**Sling Aircraft (Pty) Ltd**  
**Registration no 2002/022837/07**  
 Approved Maintenance Organisation AMO1264  
 Manufacturing Organisation M677

**SERVICE BULLETIN**

#0020 Revision 1

**SUBJECT:** Eyebolt inspection and conditional replacement

Figure 16: Flap Controls

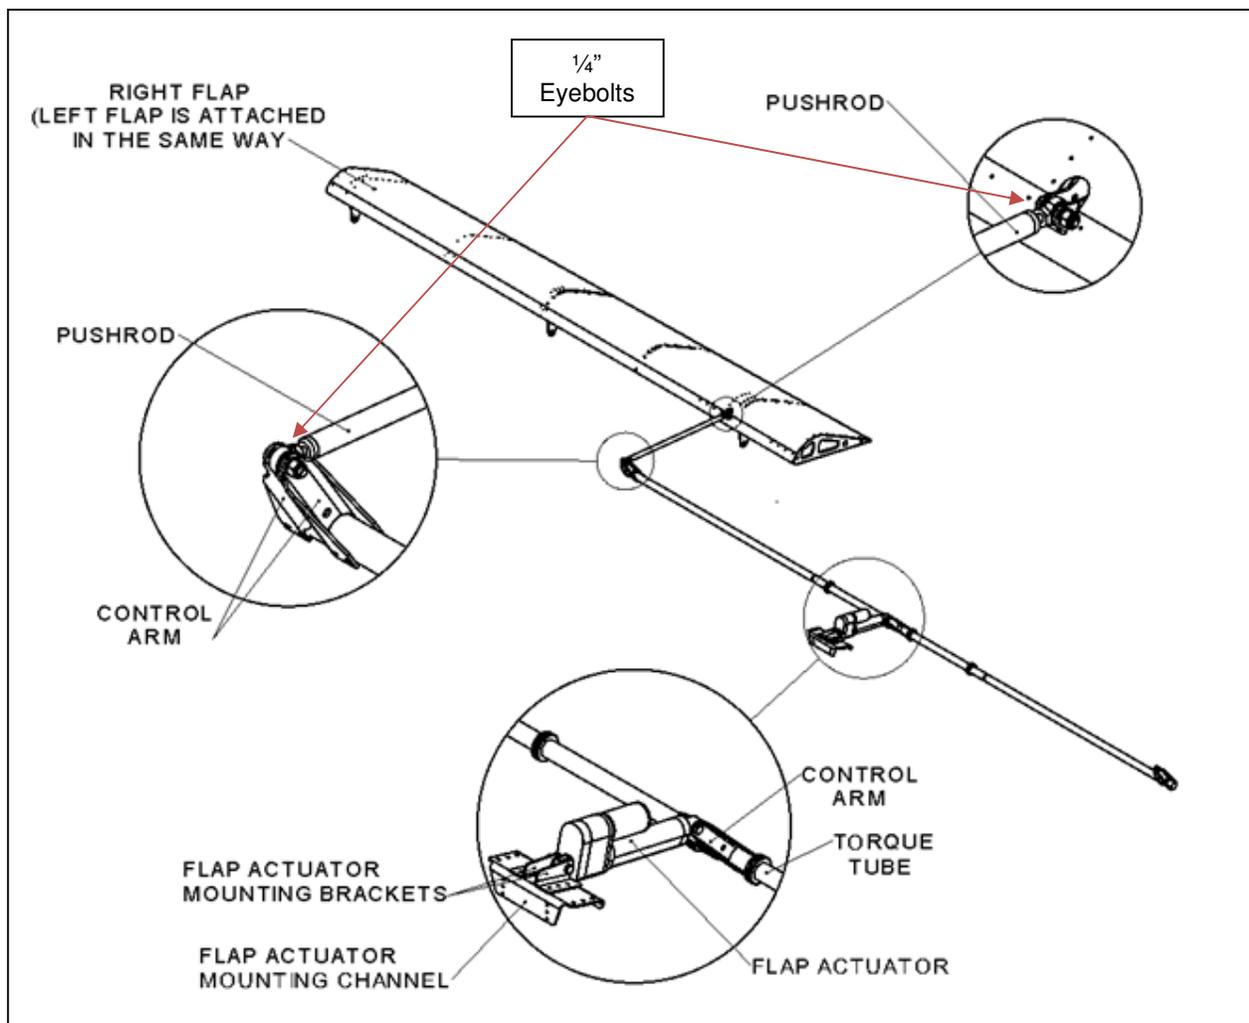
The eyebolts used in the flap control assembly can be seen in Figure 16. These can be inspected using the inspection hatches located on the wing. Due to symmetry only one flap has been shown. The same eyebolts will be found on the other side of the aircraft. The eyebolts need to be inspected and replaced where *noncompliant eyebolts* have been installed.

- Step 2. The eyebolt can then be replaced with a *type 1* or *type 2* eyebolt if required.  
 Step 3. Reverse the procedure in Step 1, to reinstall the eyebolts in the flap's leading edge.

Step 5. The eyebolt can then be replaced with a *type 1* or *type 2* eyebolt if required.

Figure 17: Sling 2 and Sling LSA elevator control system

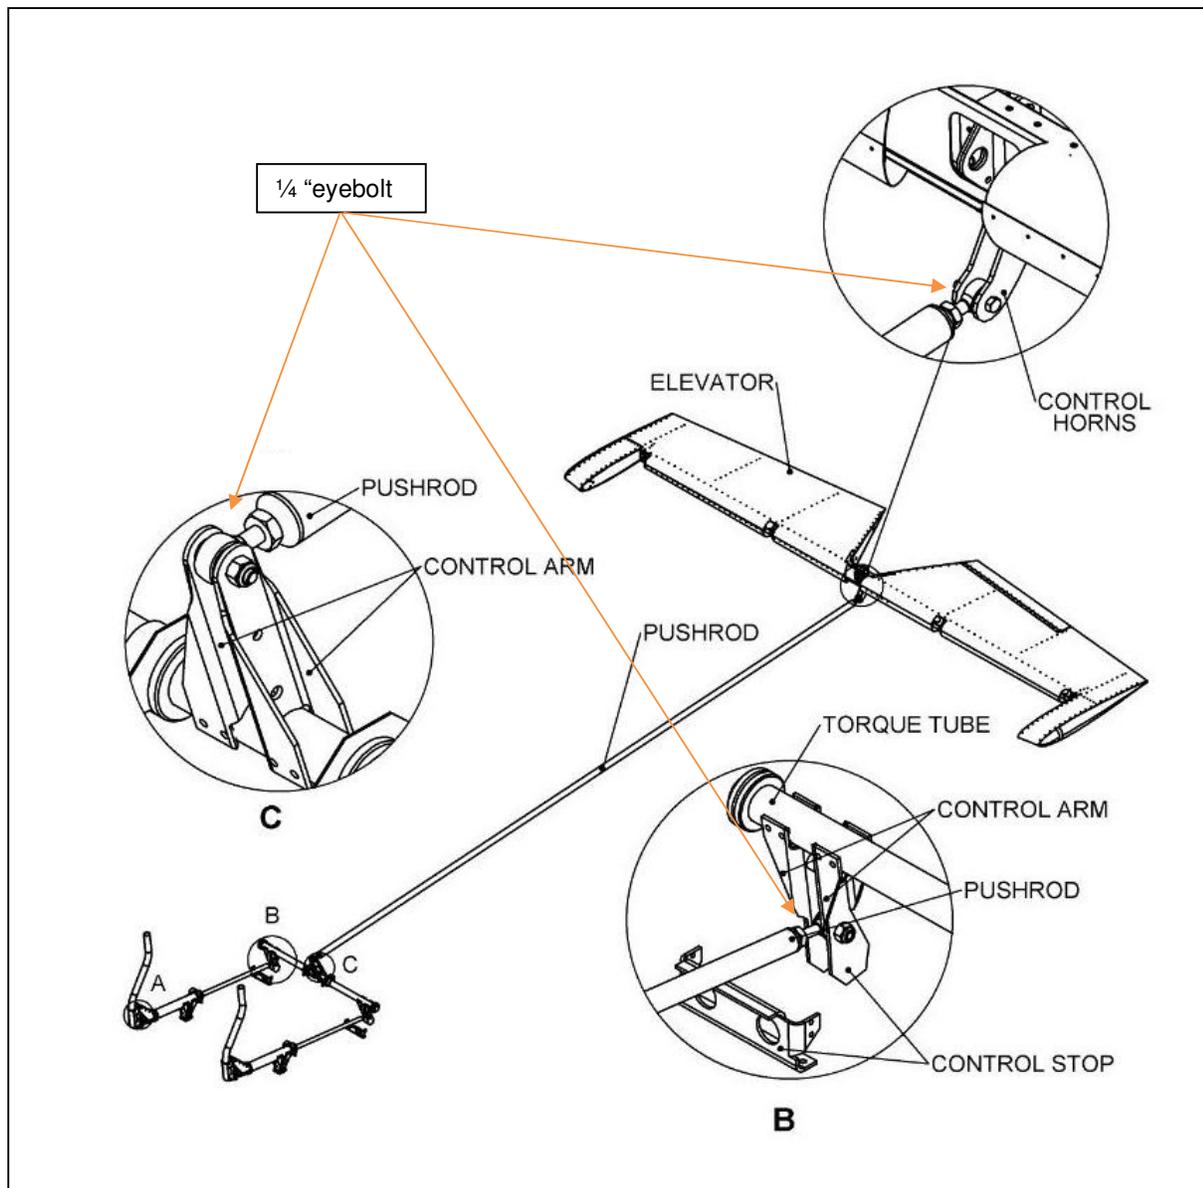
This section is only applicable to the Sling 2 and Sling LSA. The eyebolts used in the Sling 2 and Sling LSA elevator controls can be seen in Figure 17.

Figure 18: Eyebolt assembly, Detail C

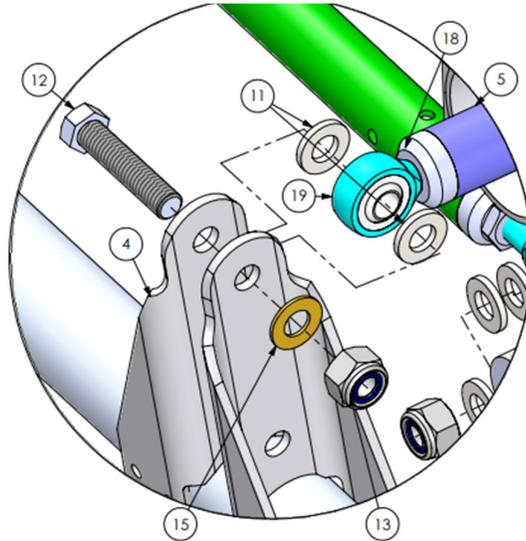
- Step 3. Refer to Figure 18. If a *noncompliant* eyebolt has been used, it must be replaced (with either a *type 1* or *type 2*). To do this, remove the AN4 locknut (13) and bolt (12). The eyebolt can now be uninstalled from the pushrod and a new one can be installed.
- Step 4. Once the new eyebolt has been installed onto the pushrod, reconnect the eyebolt assembly. Refer to Figure 18 for part layout.
- Step 5. Next, the eyebolts seen in Detail B of Figure 17 will need to be inspected and replaced if found to be *noncompliant*.
- Step 6. An enlarged view of Detail B can be seen in Figure 19.

Figure 19: Enlarged view of eyebolt assembly of Detail B

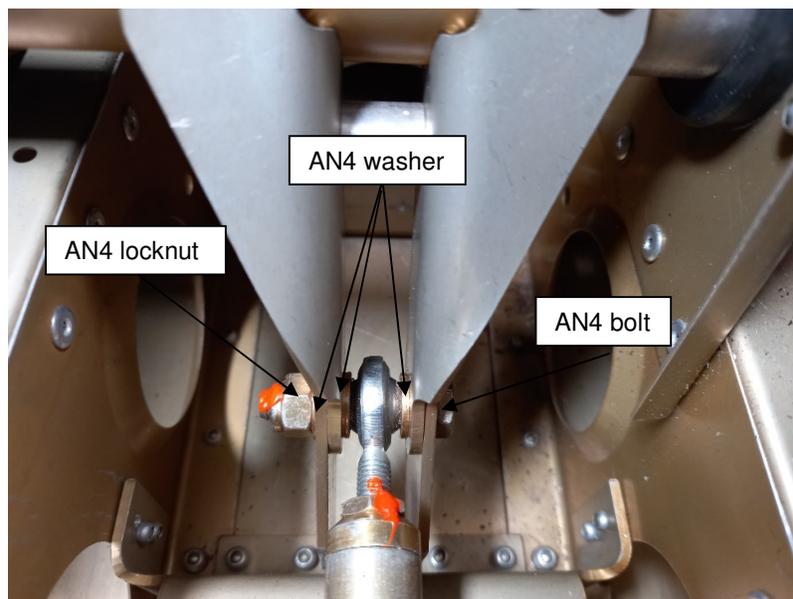
- Step 7. Refer to Figure 19 and remove the locknut and bolt.
- Step 8. Replace the *noncompliant* eyebolt with a *type 1* or *type 2*.
- Step 9. Reinstall the components, as shown in Figure 19.
- Step 10. Repeat Step 7 to Step 9 for the corresponding eyebolt assembly on the other side of the aircraft.

Figure 20

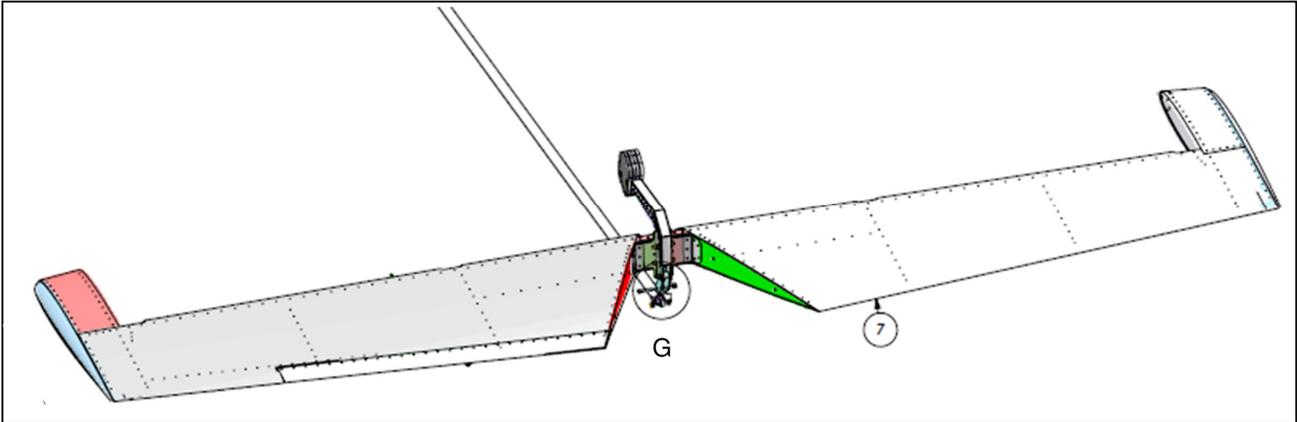
Step 11. The last eyebolt that needs to be inspected and replaced is the one connected to the elevator horn in detail G of Figure 20.

Figure 22: Detail G

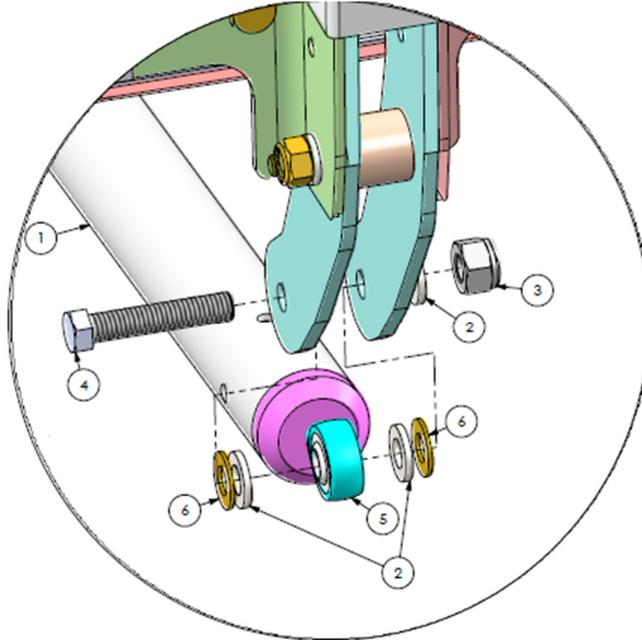
Step 13. Remove the AN4 locknut (3) and bolt (4), shown in Figure 22.

- Step 14. Replace the *noncompliant* eyebolt (5) with either a *type 1* or *type 2*.
- Step 15. Reassemble the eyebolt assembly as seen in Figure 22.
- Step 16. You will need to adjust the elevator once the new eyebolts are installed to ensure correct elevator deflection. To do this follow the instructions in the applicable MAM shown in the table below:

Figure 23

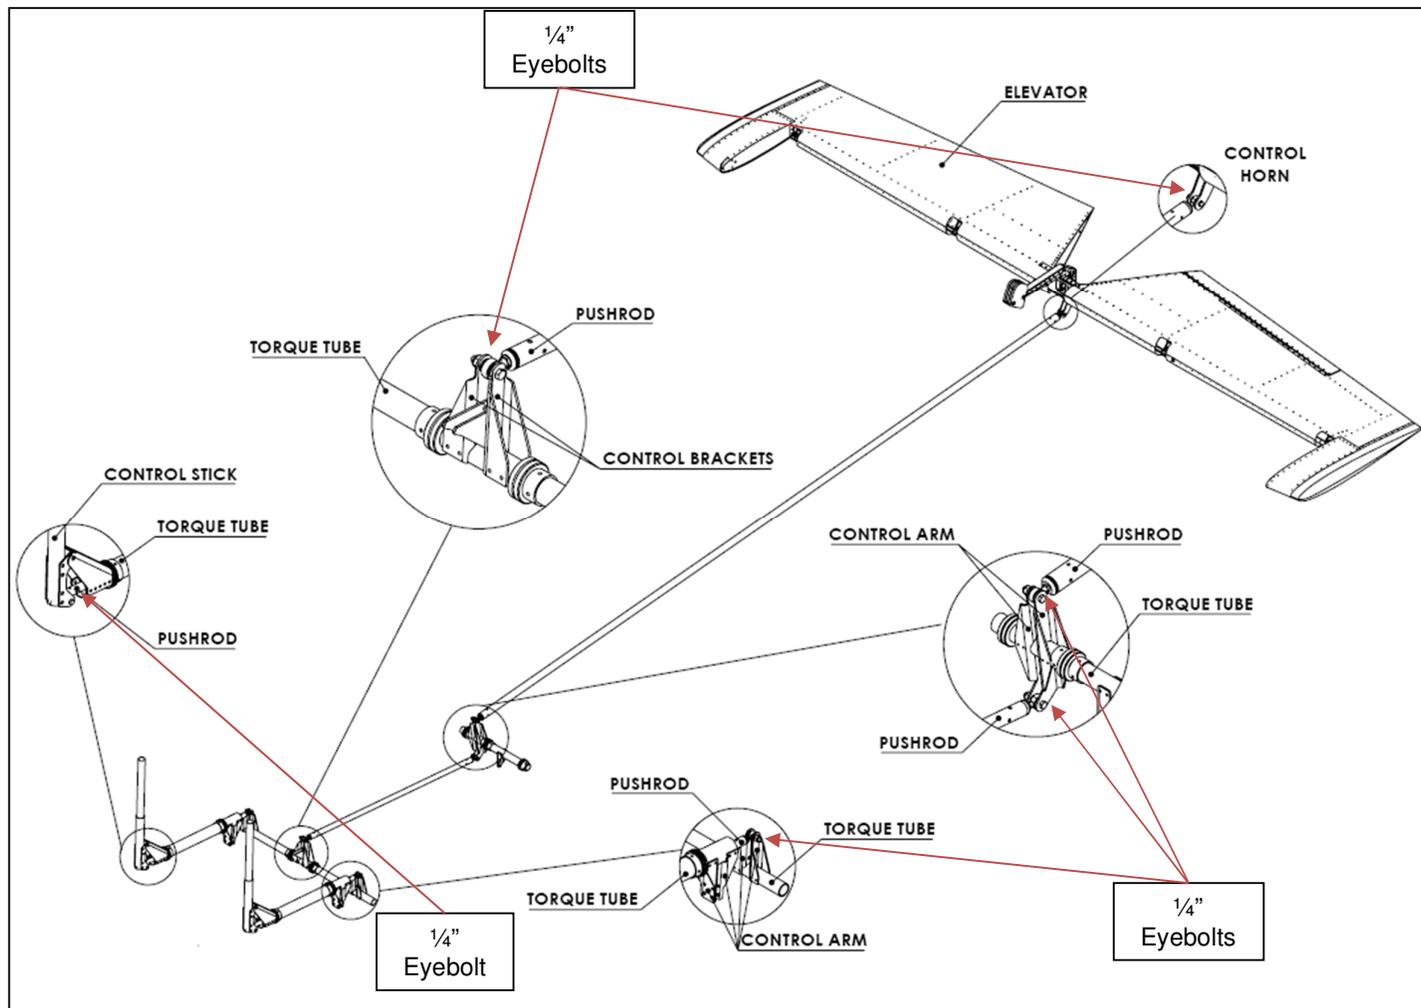
This section is only applicable to the Sling 4 and Sling 4 TSi. The eyebolts used in the elevator controls can be seen in Figure 23. The eyebolts need to be inspected and replaced where *noncompliant* eyebolts have been installed.

Figure 24: Eyebolt assembly, Detail A

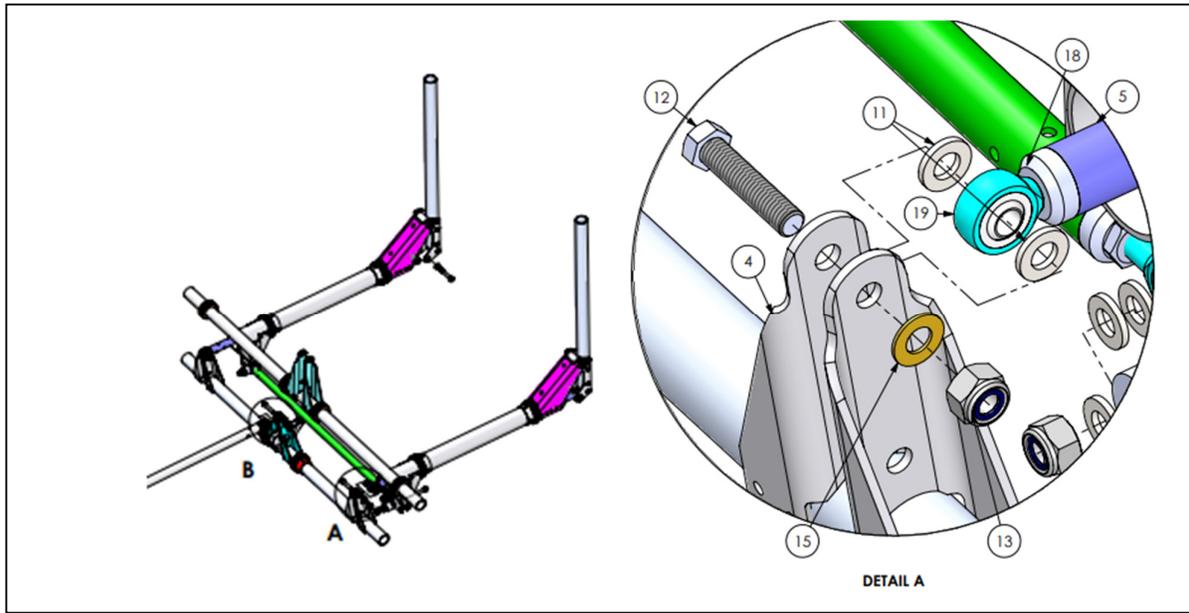
- Step 3. If *noncompliant* eyebolts have been used, they must be replaced (with either *type 1* or *type 2*). To do this remove the AN4 locknut (13) and bolt (12), as seen in Figure 24. The eyebolt can now be uninstalled from the pushrod. Once uninstalled, install a new one of either *type 1* or *type 2*.
- Step 4. Once the eyebolt has been installed onto the pushrod, reconnect the eyebolt assembly. Refer to Figure 24 for the way the assembly fits together.
- Step 5. Next inspect the eyebolts seen in Detail B of Figure 25.

Figure 25: Eyebolt assembly, Detail B

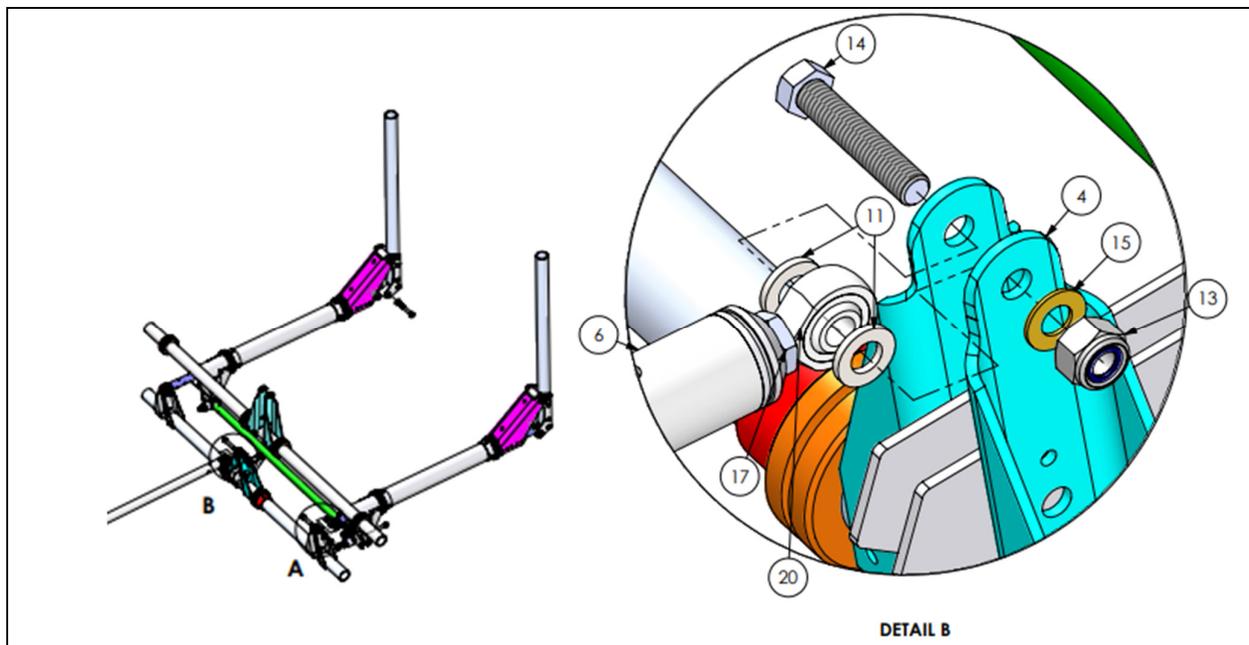
- Step 6. Remove the AN4 locknut (13) and bolt (14), as seen in Figure 25. Once removed the eyebolt can be uninstalled and an eyebolt of *type 1* or *type 2* can be reinstalled.
- Step 7. Reassemble the eyebolt assembly, refer to Figure 25 for part placement.

Figure 26

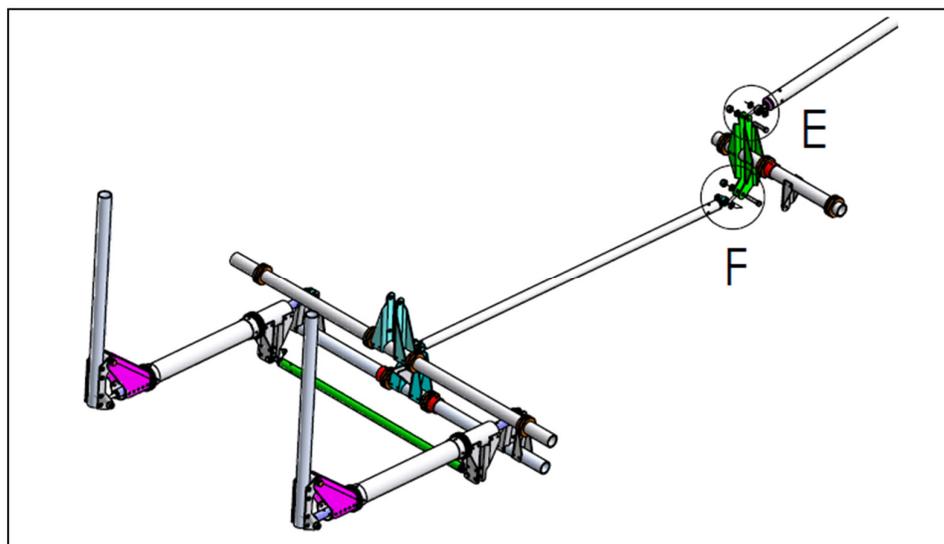
Step 8. Next, the eyebolts seen in Detail E and F in Figure 26 will need to be inspected and replaced if found to be of *noncompliant*. To access these in the Sling 4 TSi, remove the rear seats. To do this follow the instructions in the applicable MAM shown in the table below:

Figure 27: Eyebolt assembly, Detail E

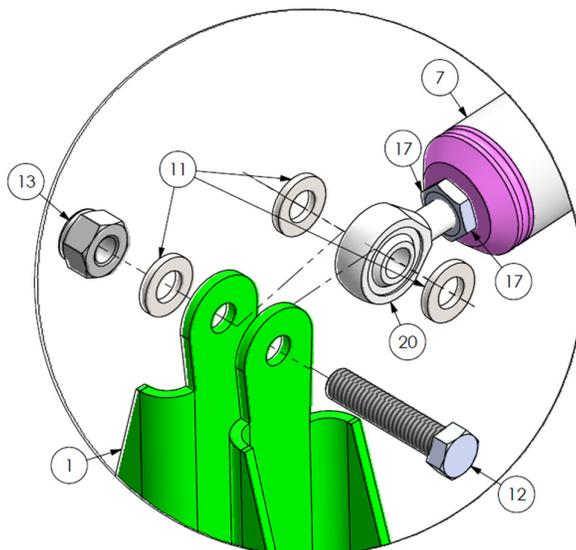
Step 9. To replace the eyebolt seen in Figure 27, remove the AN4 locknut (13) and bolt (12). Replace the *noncompliant* eyebolt (20) with either a *type 1* or *type 2* eyebolt.

Step 10. Once the eyebolt has been replaced, reassemble the eyebolt assembly. Refer to Figure 27 for component positions.

Figure 28: Eyebolt assembly, Detail F

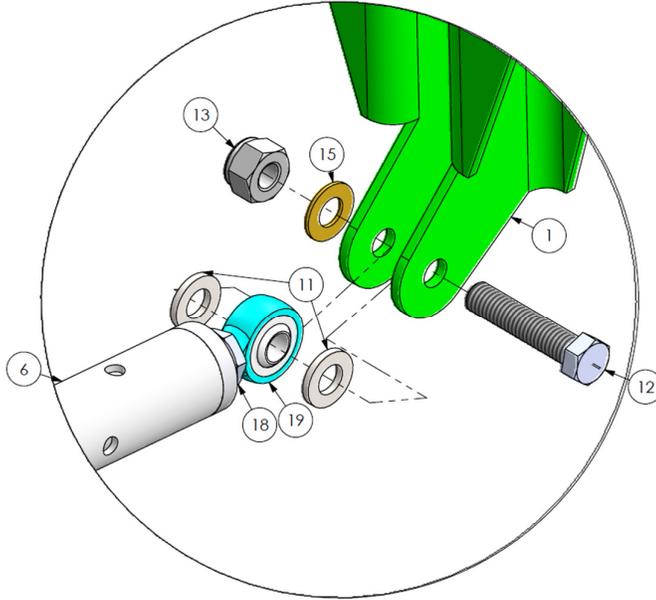
Step 11. To replace the eyebolt seen in Figure 28, remove the AN4 locknut (13) and bolt (12). Replace the *noncompliant* eyebolt with either a *type 1* or *type 2* eyebolt.

- Step 12. Once the eyebolt has been replaced, reconstruct the eyebolt assembly. Refer to Figure 28 for component layout.
- Step 13. The last eyebolt that needs to be inspected and replaced is the one connected to the elevator horn, located in detail G of Figure 29.

Figure 31: Detail G, exploded view

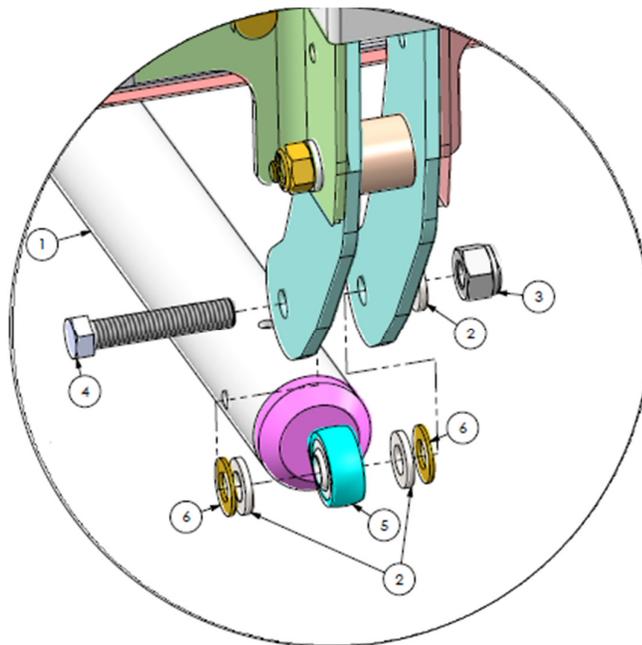
Step 15. Remove the AN4 locknut (3) and bolt (4), shown in Figure 31.

Step 16. Replace the eyebolt (5) with either a *type 1* or *type 2*.
